BIDDERS BULLETIN

PROJECT: Gateway Realty of North Platte
North Platte, Nebraska

BB-1

DATE ISSUED: February 7, 2014

DATE: February 4th, 2014
DRAWING: A801.5
FROM SHEET: A801

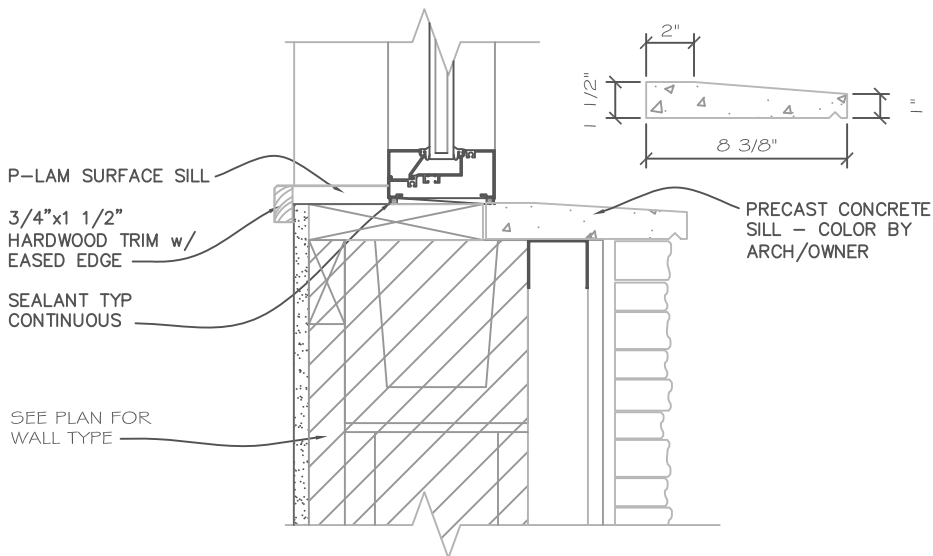
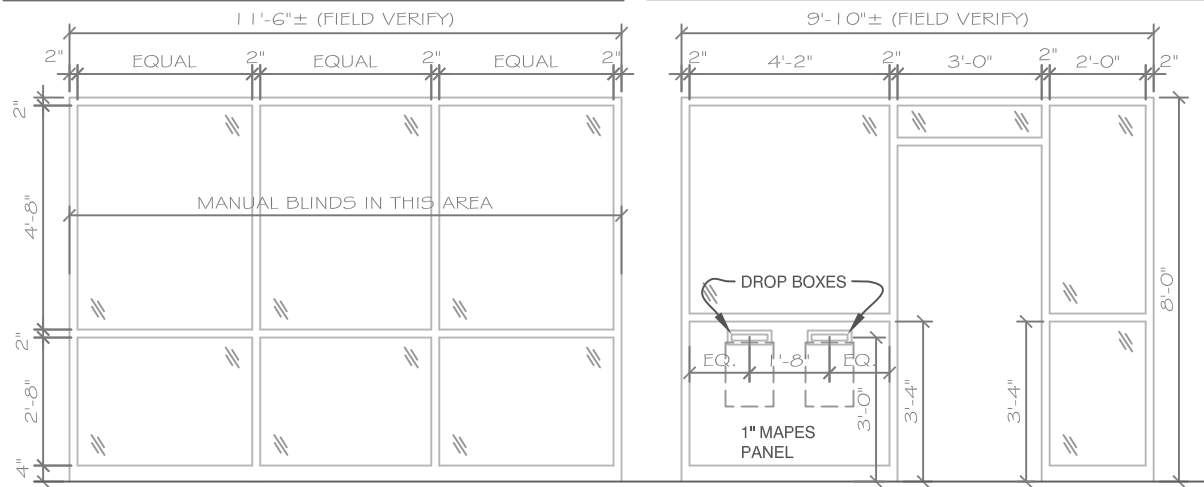
- Add detail where gyp wall meets aluminum window frame. See attached detail D21/A801 on drawing sheet A801.4
- Add window sill detail exterior walls. See attached detail D22/A801 on drawing sheet A801.5
- Add (2) Drop Boxes. See attached details D23/A801 on drawing sheet A801.6
- Add building expansion detail where new addition meets existing. See attached detail D24/A801 on drawing sheet A801.7

DATE: February 4th, 2014
DRAWING: S102.1
FROM SHEET: S102

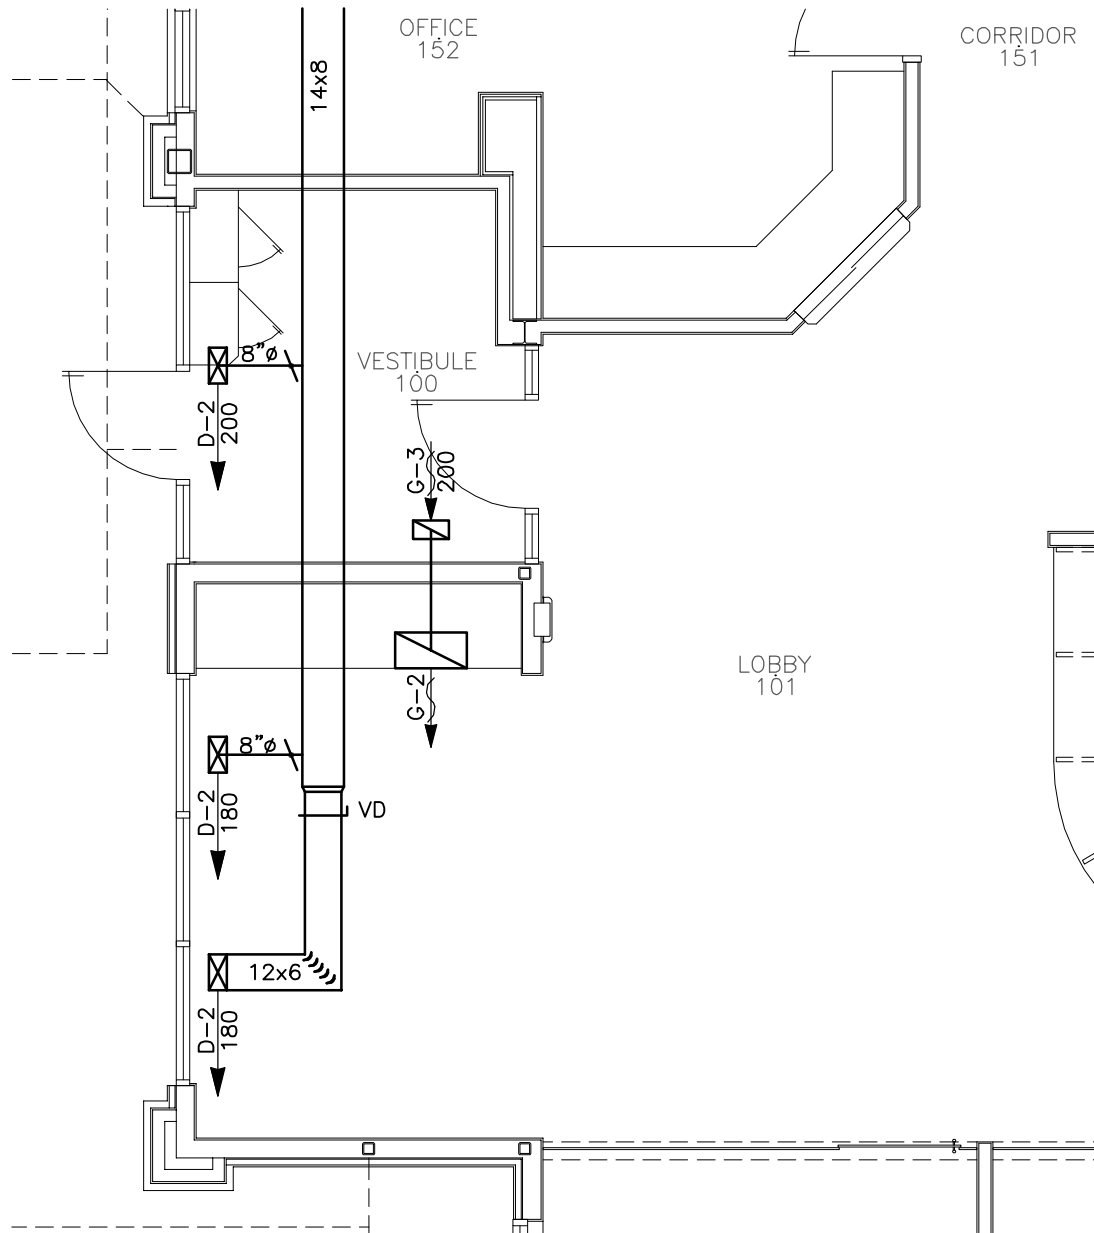
- Refer to sheet S102.1 for changes at Vestibule 100 & Coffee Bar 153

DATE: February 6th, 2014
DRAWING: M101.1
FROM SHEET: M101

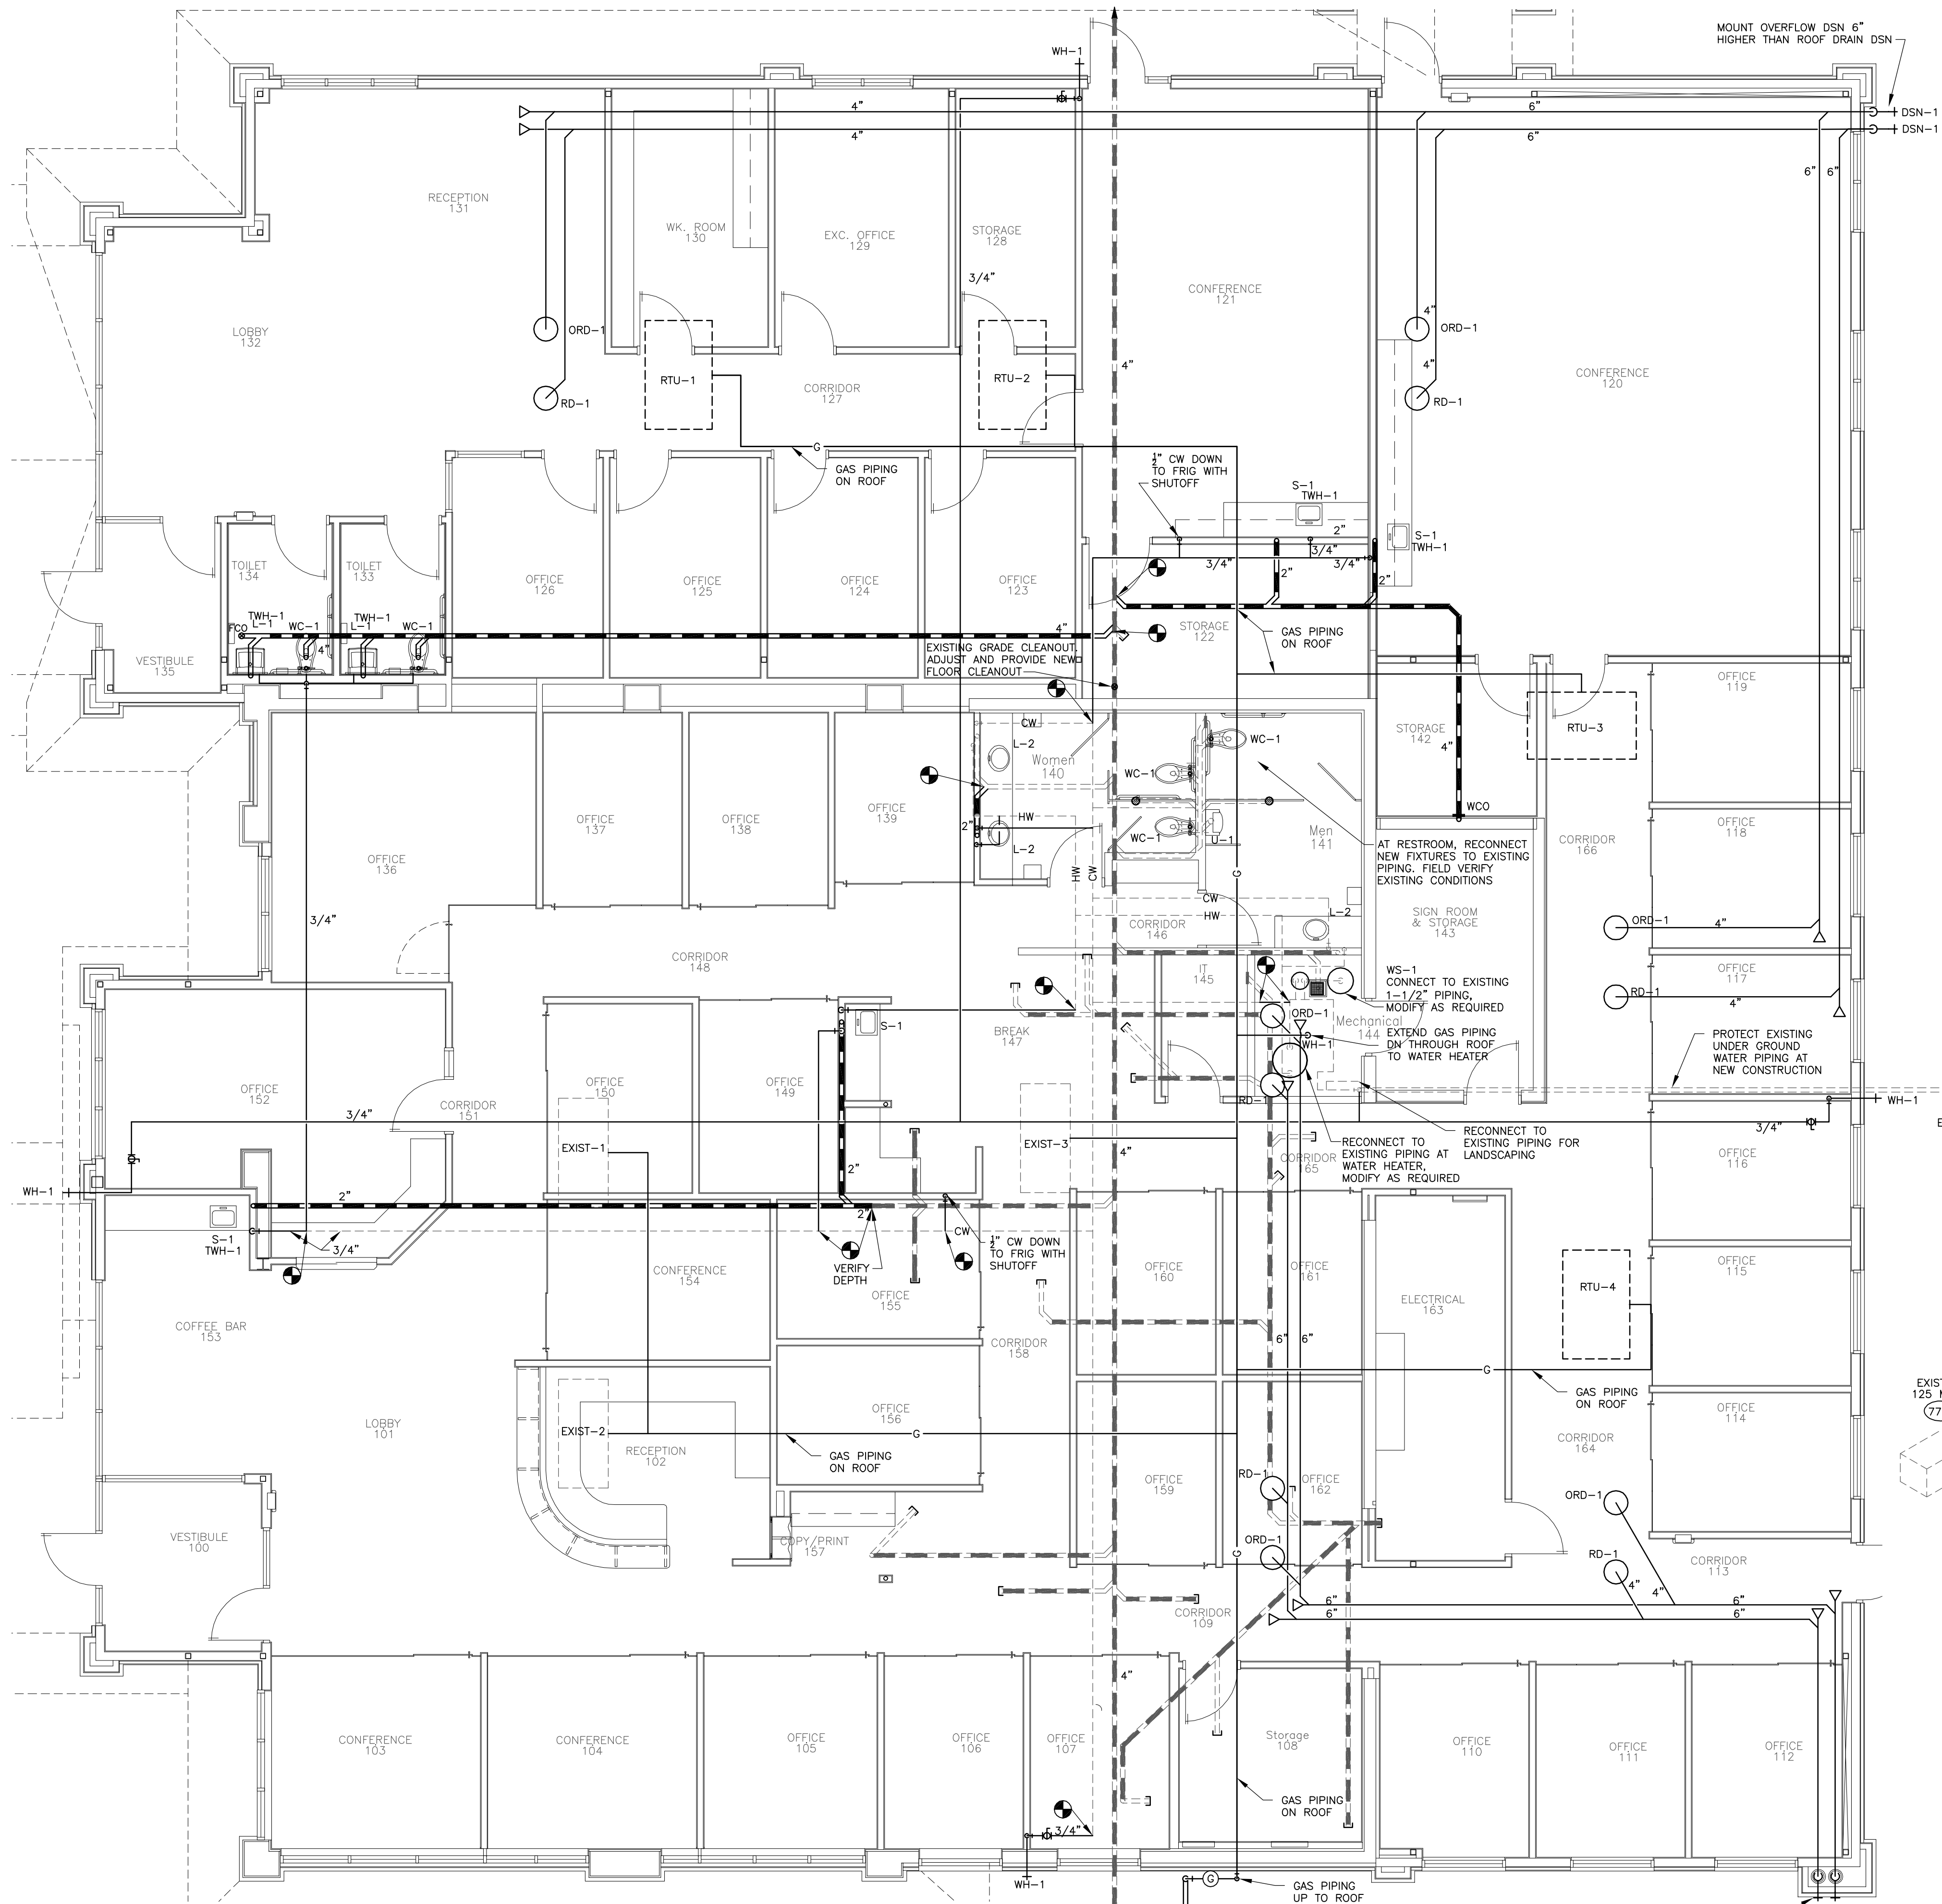
- Refer to sheet M101.1 HVAC Plan:
 - HVAC modified to accommodate revised floor plan
